# DSSAD for ALKS

**Chinese Proposal for DSSAD for ALKS**

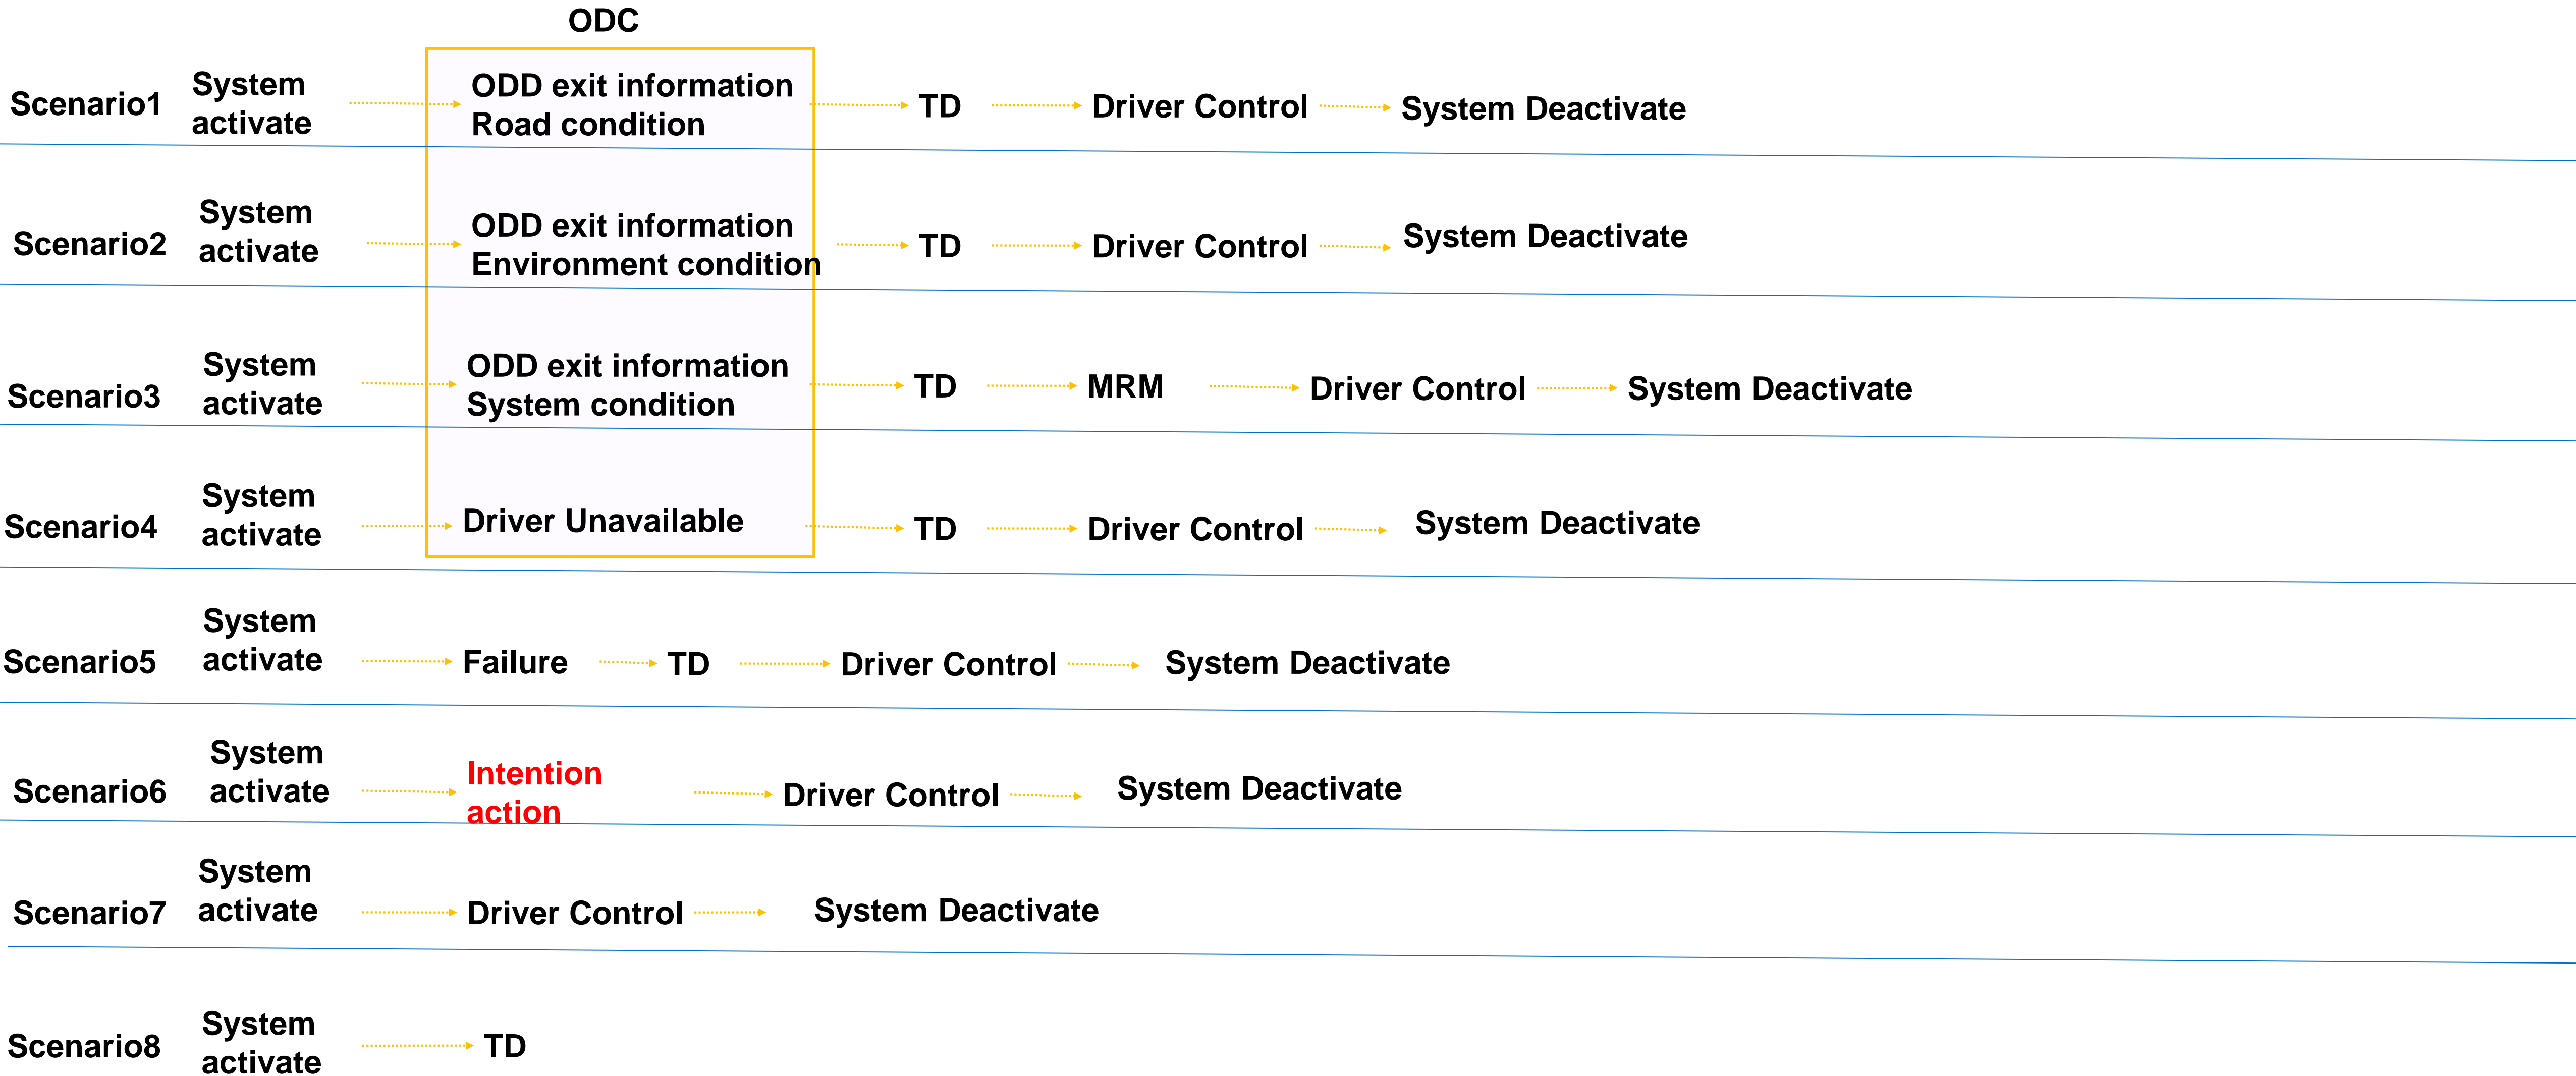
**Each vehicle with a DSSAD shall meet the requirements specified below:**

**Each vehicle with a DSSAD for ALKS shall meet the requirements specified below:**
